# **3 VOLT FlashFile™ MEMORY**

## **28F004S3, 28F008S3, 28F016S3**

### **SPECIFICATION UPDATE**

Order Number: 297799-009

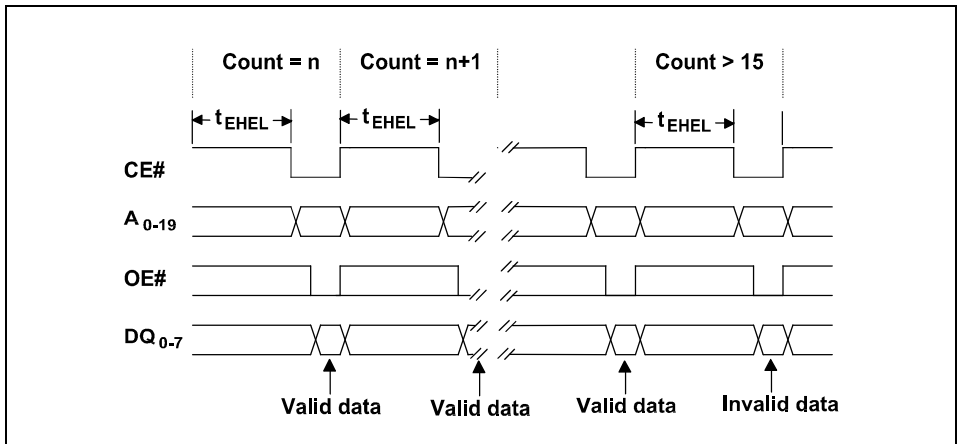
**PROBLEM:** For the 8- and 16-Mbit devices that are effected by this erratum, the block unlocking security feature is currently nonfunctional. Attempts to unlock blocks, using the clear block lock-bits command sequence, may cause subsequent program and/or block erase failures. The failure is seen as a device protection error in the status register.

**IMPLICATION:** Block unlocking feature is disabled. This erratum effects the following command, Clear Block Lock-Bits. Locking blocks using the Set Block Lock-bits command (while RP# is equal to 12 volts) is still supported.

**WORKAROUND:** To prevent accidental software block lock-bit clearing, Intel permanently sets the master lock-bit during the test flow. This disables the ability to lock and unlock blocks via software only with RP# = V<sub>IH</sub>. Block locking and unlocking requires 12 V on the component's RP# input when the master lock-bit is set. Don't execute the clear block lock-bits command sequence when 12 V is applied to RP#. Instead, simply override the block locking mechanism by applying 12 V to RP# to enable program/erase operations that target locked blocks.

If data security is of utmost importance, lower V<sub>PP</sub> voltage equal to or less than V<sub>PPLK</sub> during normal operations. With V<sub>PP</sub> equal to or less V<sub>PPLK</sub>, the device is protected against all data manipulation operations.

**Successive Read Operations That Have Long CE#-High Pulse Widths**

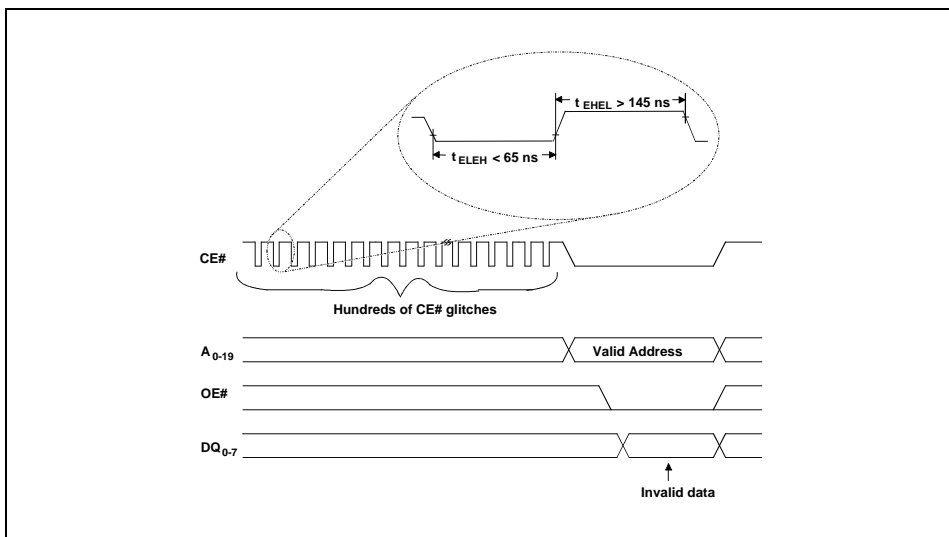
**PROBLEM:** The component may return invalid data if more than fifteen successive read operations are performed where CE# is deasserted between each read and the corresponding CE#-high pulse width resides within the specifications outlined in the table below.

Stepping	CE#-High Pulse Width ( $t_{EH\text{EL}}$ )	
	Min	Max
A-1 and -3	100 ns	40 $\mu\text{s}$
A-6	240 ns	700 ns

1. Read more than four good reads for A-1 and A-3 stepping and only one read for A-6 stepping during each assertion of CE#, as illustrated in the figure above.
2. Issue a Byte Write command and program FFh to any location before executing a read operation. Programming FFh will not alter stored data, but it will give the component sufficient time to prepare for the read operation.

**A Long Series of CE# Glitches May Induce an Invalid Read**

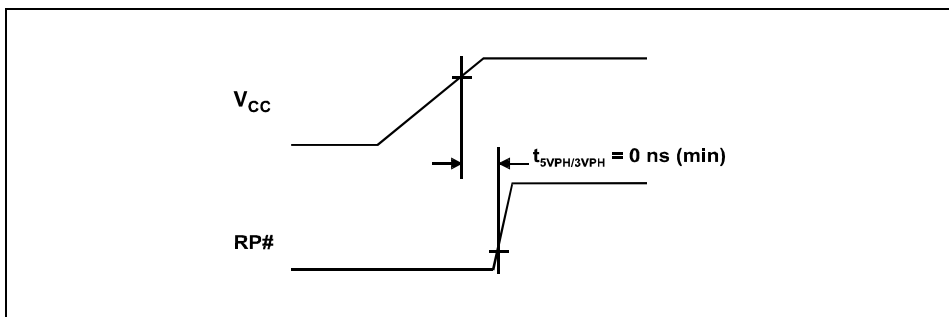
**PROBLEM:** A noisy CE# control signal may cause an invalid read. This erroneous read only occurs after the device has received over one hundred consecutive short CE# glitches ( $t_{EHL} < 65$  ns) with CE#-high time ( $t_{EHL}$ ) greater than 145 ns (see the figure below, *A Long Series of CE# Glitches May Induce an Invalid Read*).

After valid data is read, the device must receive another series of CE# glitches (typically over one hundred) to induce an invalid read.

If the device receives over one hundred consecutive CE# glitches, issue a Byte Write command and program FFh to any location before executing a read operation. Programming FFh will not alter stored data, but it will give the component sufficient time to prepare for the read operation.
